PLANNING REPORT

Planning and Zoning Commission

Livewell Vet Clinic 25-100CP

Case Summary

Proposed Site Plan

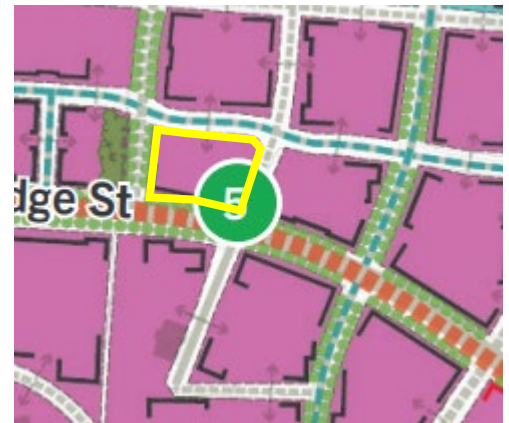
This request shows a single rectangular building on the west side of the site, with the potential for a second building on the east side. Only the first phase/west site is considered for this CP at the applicant's request: the second phase/east side is shown for context and would require its own CP. The west building is adjacent to W. Dublin Granville Road and the future Village Parkway extension. Parking is shown to the north with access from Banker Drive. The west building's entry is at its southeast corner, adjacent to W. Dublin-Granville, and includes adjacent public open space.

1) Does the Commission support the proposed use and layout?

The Mixed-Use Urban FLU includes commercial and office as principal uses. The BSD Special Area Plan envisions pedestrian-oriented office with supporting retail. A three to six story format is envisioned; however, this needs to be balanced with the deed restrictions (maximum 28' tall). Veterinary offices are a permitted use within the Sawmill Center Neighborhood.

The site is a single lot: the applicant desires to record a condominium plat to separate each building and parking. Two buildings are in conflict with the City's understanding of the deed restrictions, and the City is mindful that the second phase may not materialize. If this is the case, then the first phase alone would result in a very suburban layout, in conflict with District vision. Staff has also relayed to the applicant the need to verify feasibility of the condo approach relative to water service from the City of Columbus, as one water tap is typically permitted per lot.

No stormwater facilities are shown on the plan at this early stage; these will have to be accommodated should the project move forward. Water quality and quantity will be required, and above ground detention is not permitted, unless it is an amenity. The applicant will need to work with staff to demonstrate compliance with Chapter 53 of the Dublin Code.

Given the proposed parking's proximity to future Village Parkway, a street wall may be required along that PFS in addition to the required landscaping. Additional refinements to the landscape plan will also be needed at the more formal stages to ensure compliance with the other applicable standards.

Site superimposed on SCN Map

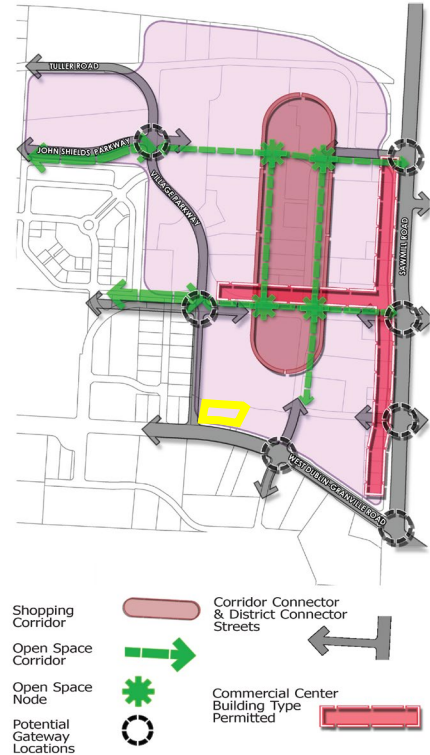
The applicant is proposing to utilize the Commercial Center Building Type, which is not permitted in this location per Code Figure 153.063A; these buildings are permitted only along Sawmill Road and a limited stretch of Bridge Park Avenue. Given the building height and size restrictions of the Lowe's deeds, the Commission may consider whether a Waiver would be warranted and whether this is the correct building type. For Case 22-028 (see below), Waivers were granted to allow a single-story Loft Building, plus additional height for that building, to allow for variations in massing. Because of the connecting roof, that building was considered to be one structure as required by the deed restrictions. The PFS façade, shown below, was highly interactive and pedestrian oriented.

Site superimposed on street network

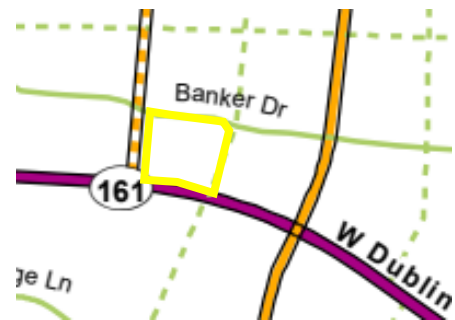
The site currently has frontage on three streets. W. Dublin Granville Road is a Corridor Connector/PFS on the south, and Banker Drive is a private Neighborhood Street on the north. The private Lowe's driveway forms the east border of the site and is also a Neighborhood Street. The street network plan also shows the future Village Parkway extension directly to the west, which would be a District Connector and PFS. This future right-of-way will occupy some of this lot's western edge, and side/corner Required Building Zones (RBZ) will need to be accommodated based on the future condition. Additional improvements along W. Dublin Granville include accommodation for the planned BRT route. Exact details are being finalized; however, this location will need an additional 17 feet +/- of right-of-way.

Should the application move forward, the applicant would be required to continue to work with staff to finalize the implementation and construction of the road network. The BSD Streetscape Character Guidelines identify Banker Drive and the Lowe's private drive as Standard Streetscapes, with on-street parking with permeable brick pavers, granite curbs, concrete sidewalks, and planting strips or tree grates. W. Dublin Granville Road and the future Village Parkway, are Signature Streetscapes, which include brick sidewalks.
